RFB-2024-20 SUNY SCCC ELSTON HALL LOBBY AND MOHAWK ROOM RENOVATION C2 DESIGN GROUP

ADDENDUM #2

Issued Date: 06/10/2024

Reflected Ceiling Plan - Mohawk Room

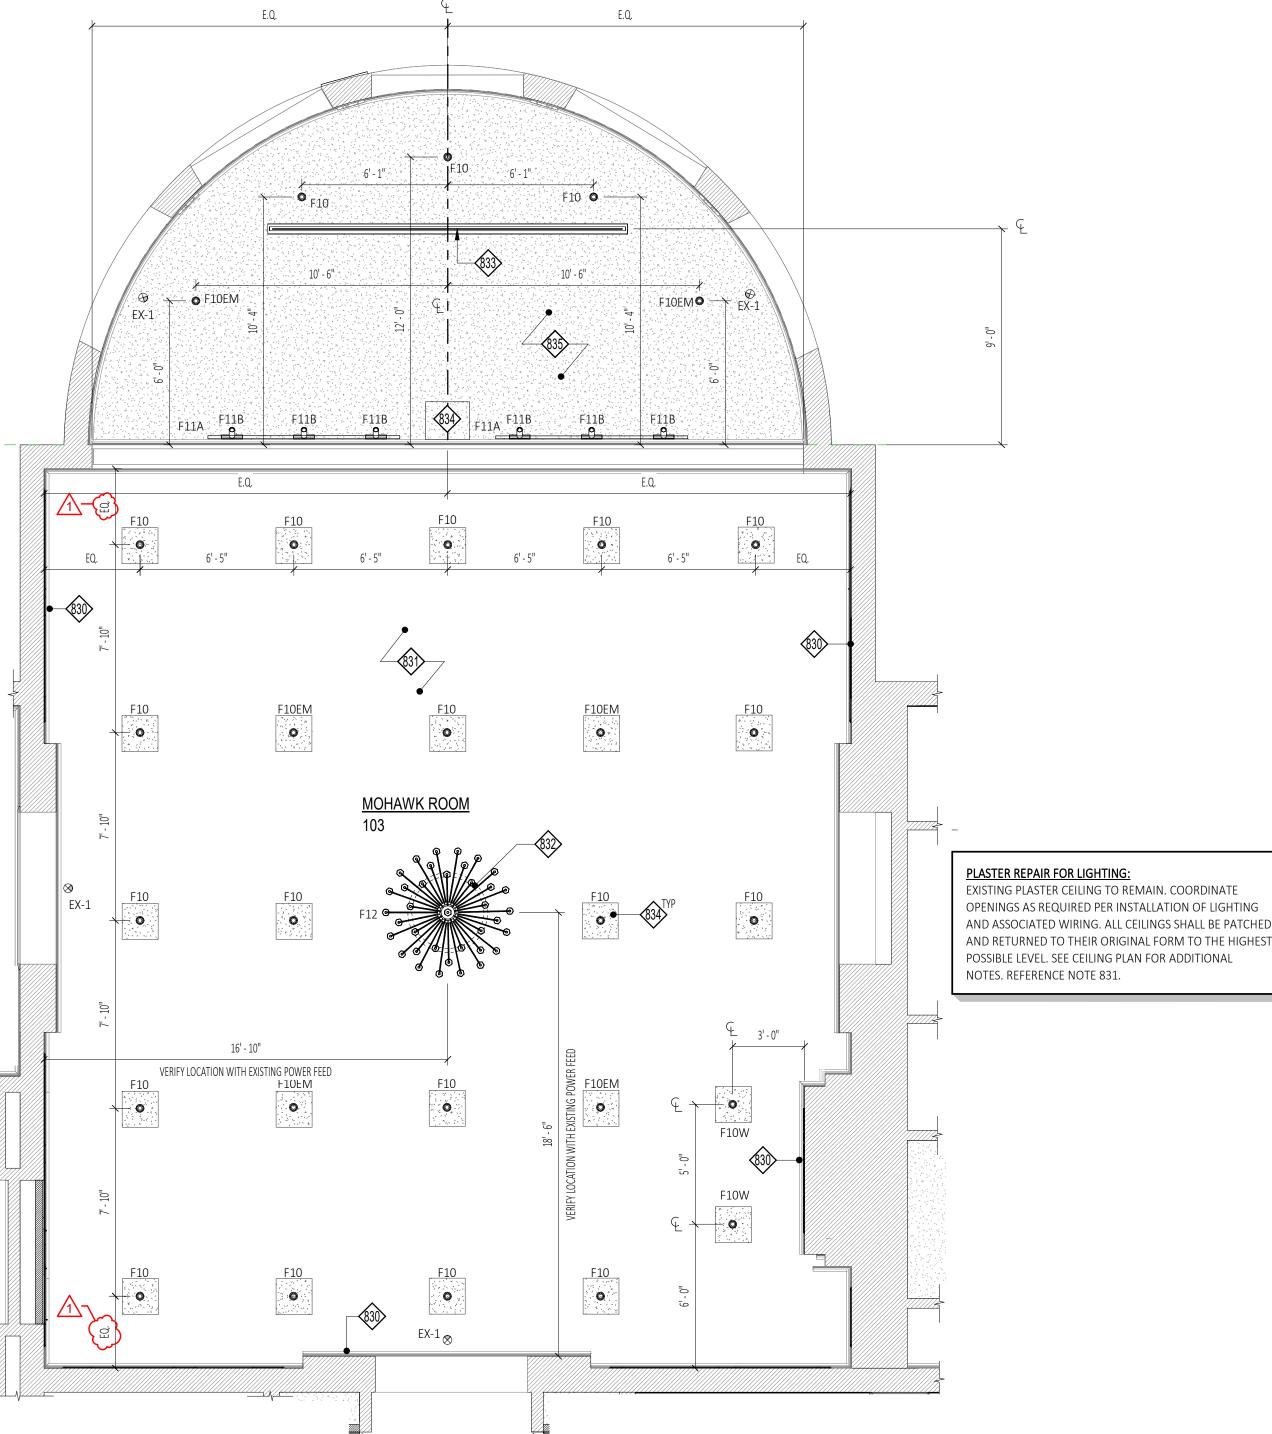
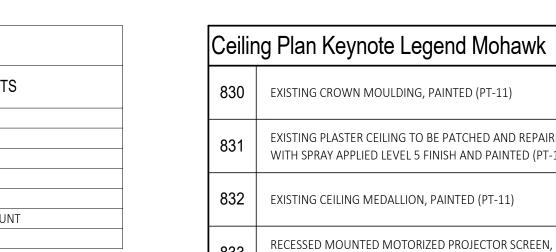
- 1. **Second walkthrough** Contractor sign in Sheet, May 29, 2024 at 9:00 am
- 2. Electrical Drawings E201A, E201B, and E701- Revisions as marked Addendum #2 06/07/2024.
- 3. Architectural Drawings A800B, A880A and A901A- Revisions as marked Addendum #2 06/07/2024.
- 4. <u>Front end Specifications XXIII Affirmative Action Requirements</u> Division 0 00-02-05 page 14 of 107, Replace XXIII Affirmative Action Requirements with attached revised section XXIII.

MOHAWK ROOM LIGHTING PLAN - ALTERNATE #1 E201B SCALE: 1/4" = 1'-0"

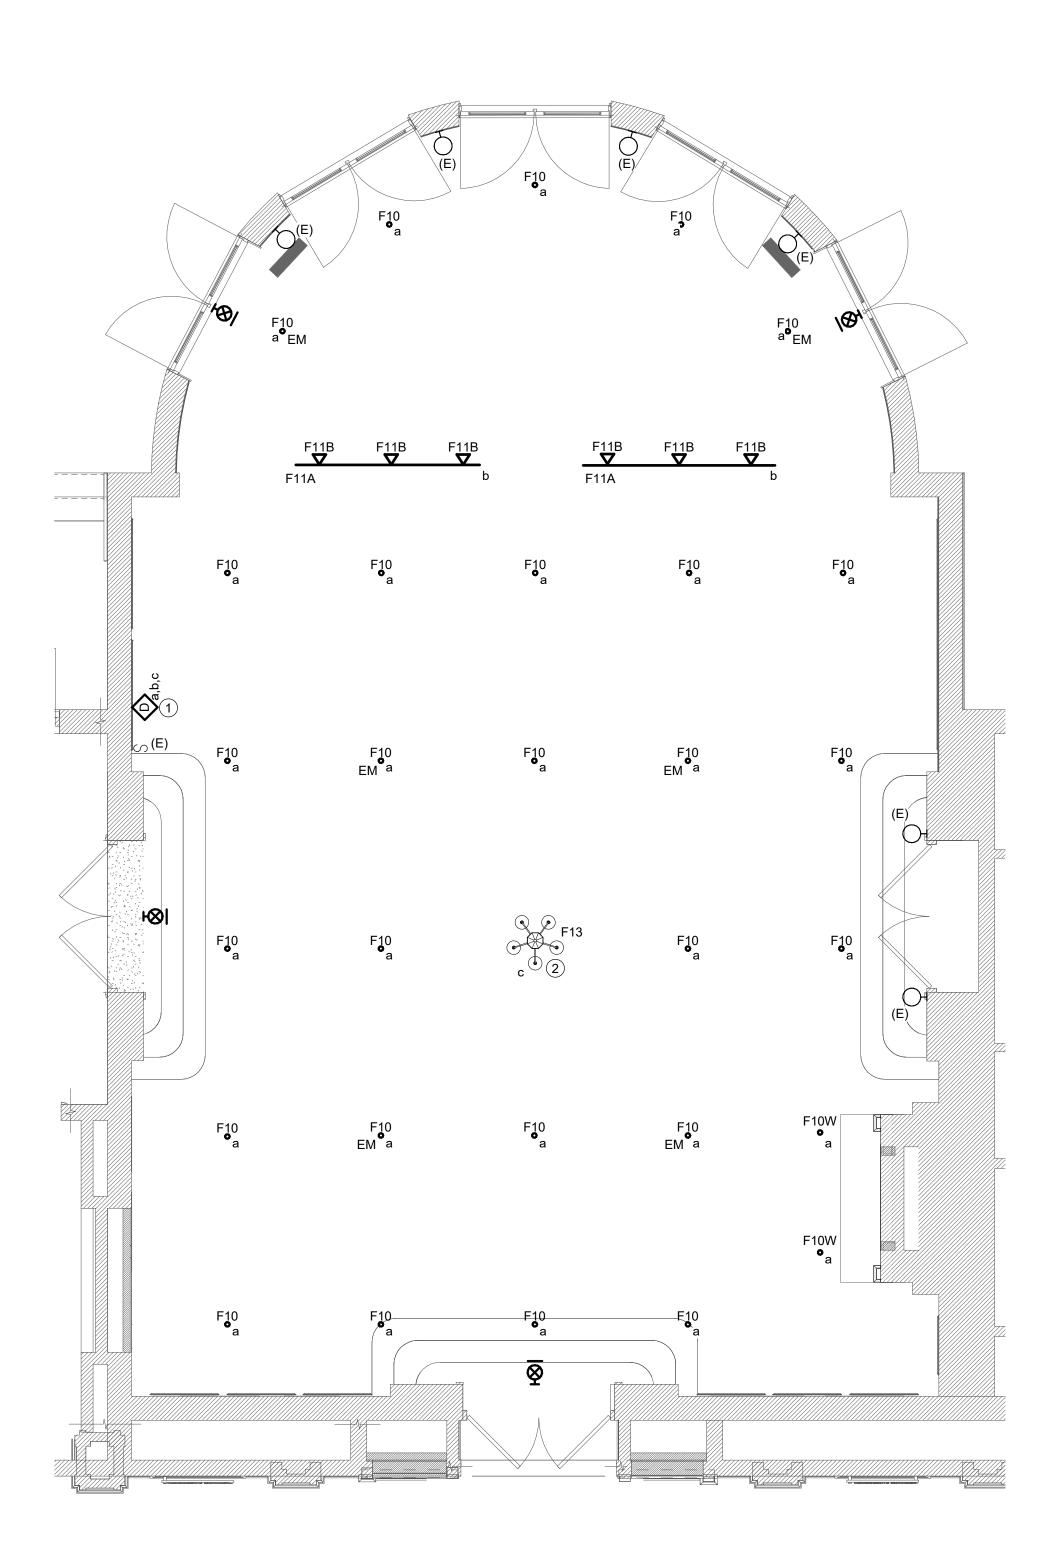
- PROVIDE LEDRA BRANDS WIRELESS CONTROL PLATFORM SWITCH(ES) FOR ON/OFF AND DIMMING CONTROL OF MOHAWK ROOM LIGHT FIXTURES (CASAMBI SWITCH 55 SERIES). PROVIDE (1) CR03 HANDHELD REMOTE CONTROLLER AT PODIUM.
 - PROVIDE FDELV600W ELV POWER PACK FOR WIRELESS CONTROL OF CHANDELIER BY
 - LEDRA BRAND SWITCHES.
- munimum manumum menter and menter
